**POLICY COORDINATING COMMITTEE
CANCELATION NOTICE**

POLICY COORDINATING COMMITTEE

MINUTES –SEPTEMBER 17, 2019

5a. Presentaiton/Discussion. Exposition Drive and 1st Avenue N intersection project, Andy Daleiden, Principal Engineer, Kittelson & Associates, Inc. Transportation Engineering / Planning

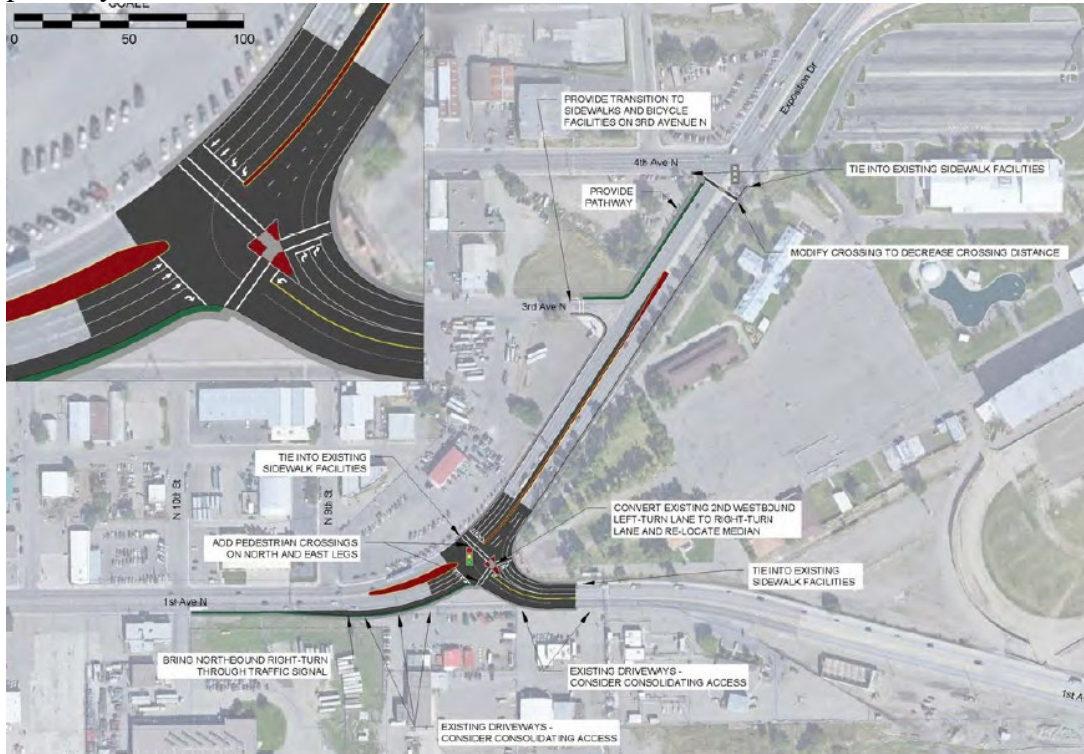
ssioner Pitman asked about the possibility of landscaping the "triangle" area created with this option and clarification was provided to Mayor Cole on the existing curb walks. Woody Woods commented on the ques, and said often times automobilists stay in the second lane and then turn right creating a lot of potential

for accidents. Mike Black commented if the 2nd lane is a right turn, further thought may be needed to que northbound truck traffic to use the outside right turn lanes.

Alternative 4-Free Westbound Right-Turn Lane. Modify westbound approach; Add 4th northbound though Lane to Bench Boulevard; Modify northbound right-turn Lane; Add crossings, pathway, and detached sidewalks.

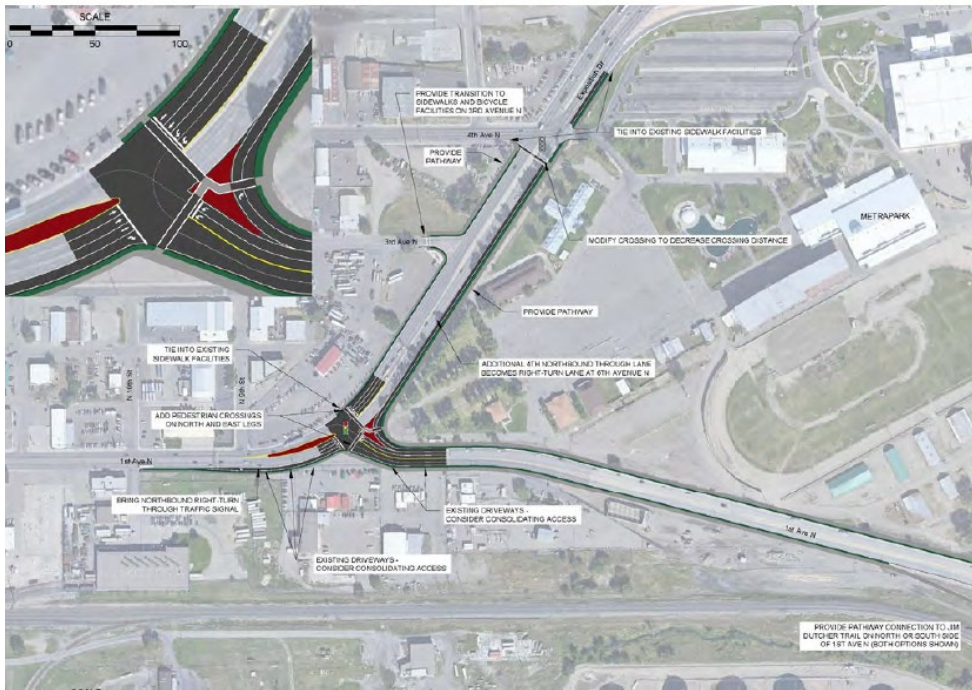
Commissioner Pitman asked if this alternative will cut off access to the businesses in this area. Mr. Daleiden said this is being explored. He explained that in an ideal situation, a move would be made to consolidate access points. They are starting to engage the business owners, and they will be meeting with Tayllor Brown today.

Mr. Daleiden said a traditional signal head will be installed if the site lines are not adequate, and an advanced signal head may be provided for the right turn movement. The crossing may be used infrequently but it is important to ensure notice. The pathway will be provided along east side of Exposition Drive and connect to 1st Ave N to Jim Dutcher Trail or facilitate connection on the south side. There are opportunities for separated pathways.

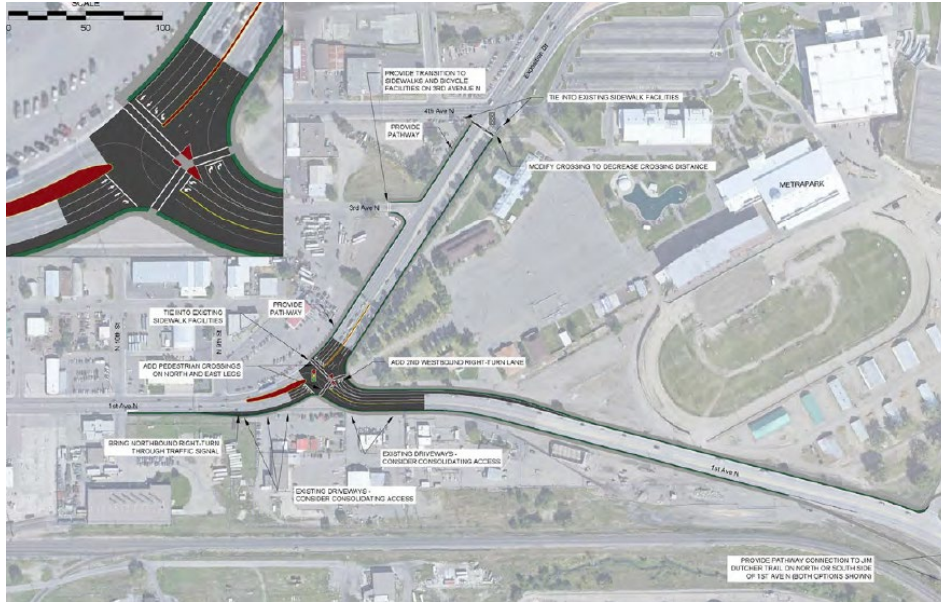
Alternative 5-Dual Westbound Right-Turn Lanes: Modify westbound approach with dual left turn lanes and dual right-turn Lane (signalized). Modify northbound right-turn Lane; Add crossings, pathway and detached sidewalks. Right turn lanes would be signalized. Woody Woods commented he likes the 2 lanes as it would provide ample room to accommodate trucks making the right turn movement.

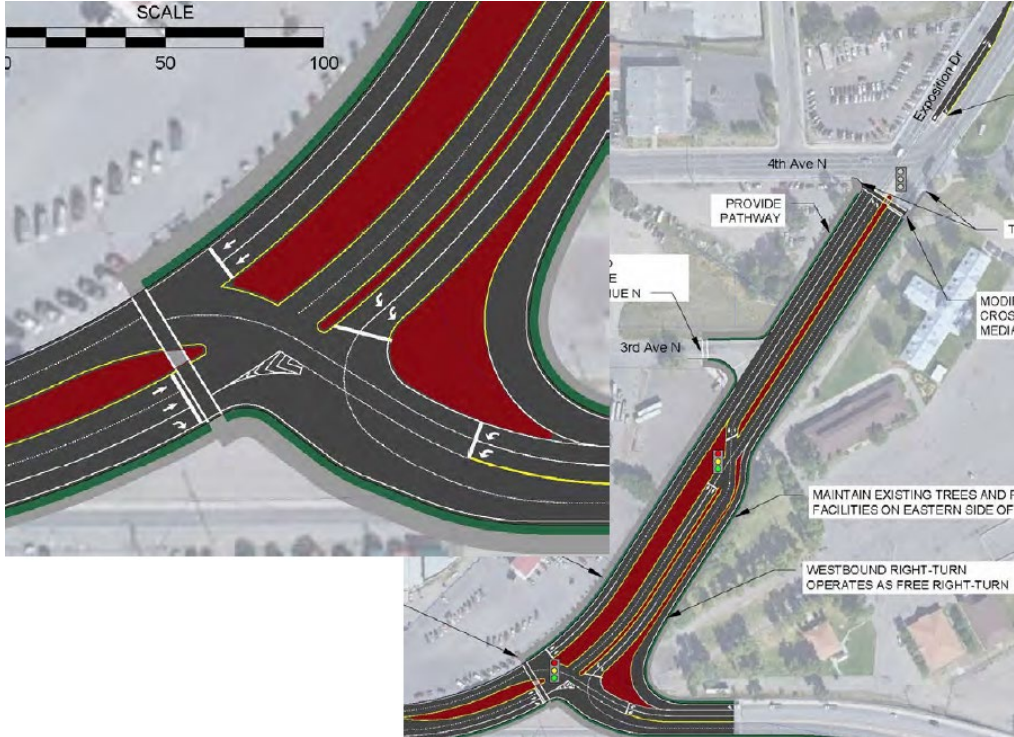
Mayor Cole voiced concern with the potential for head-on collisions if someone runs the red light. Mr. Daleiden said he can get the statistics but it is the experince of agencies who implemented this option to have had a reduction in crashes in the left turn movement and low head-on events. In terms of safety,performance conflicts are reduced. He continued with a clarification of traffic movements per request of Commisioner Pitman. WoodyWoods observed that this alternative would take quite a bit of County property.
